TITLE: TA800VE 5P

DWG NO
TA-071012-033

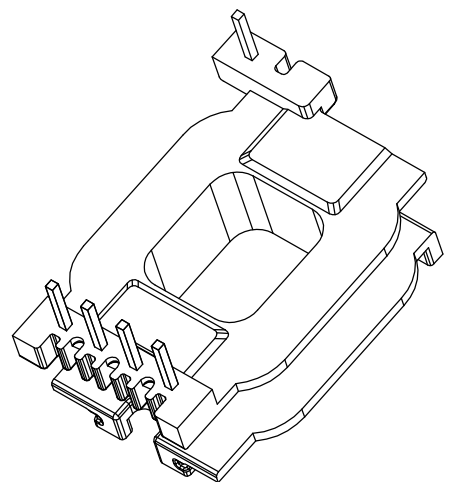
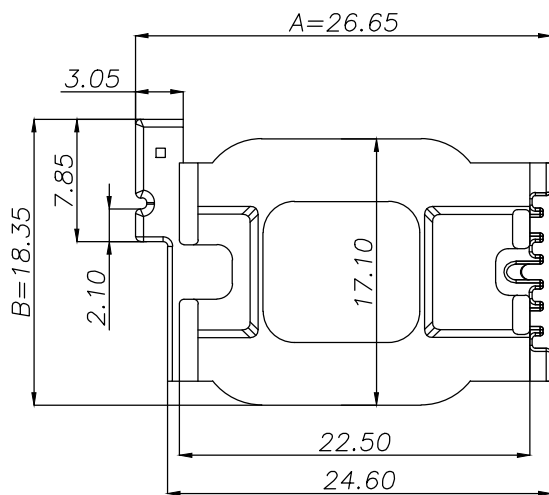
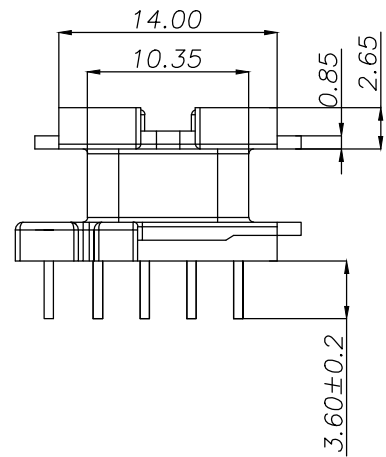
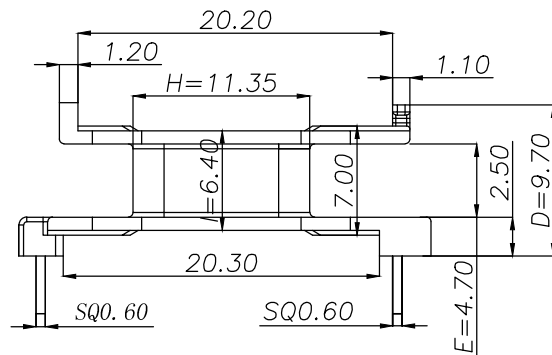
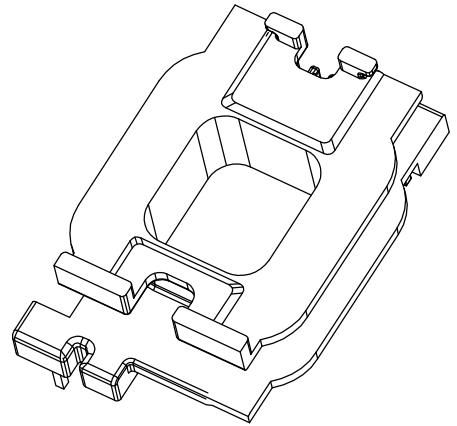
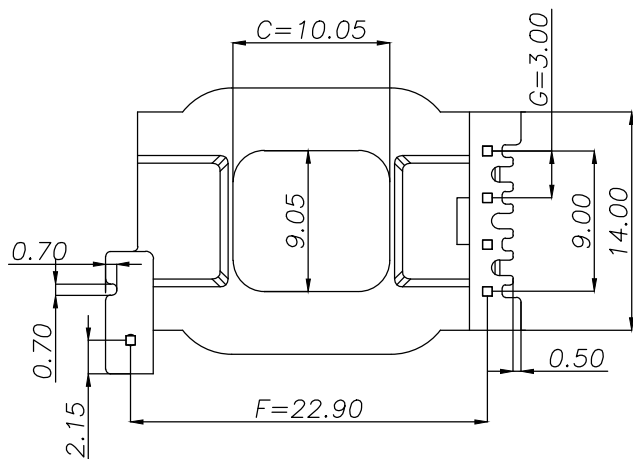
3.					
2.					
2020.02.04	二次面过线槽修改为0.70*0.70，槽位置下移0.70，5PIN胶位加宽0.20，总长度为26.65mm.				
	REVISION NOTE				
DRAWN	CHECKED	APPROVED	MATERIAL: PHENOL	UL REC. : UL94V-0	
			X=PIN LENGHT	DATE: 2019.12.02
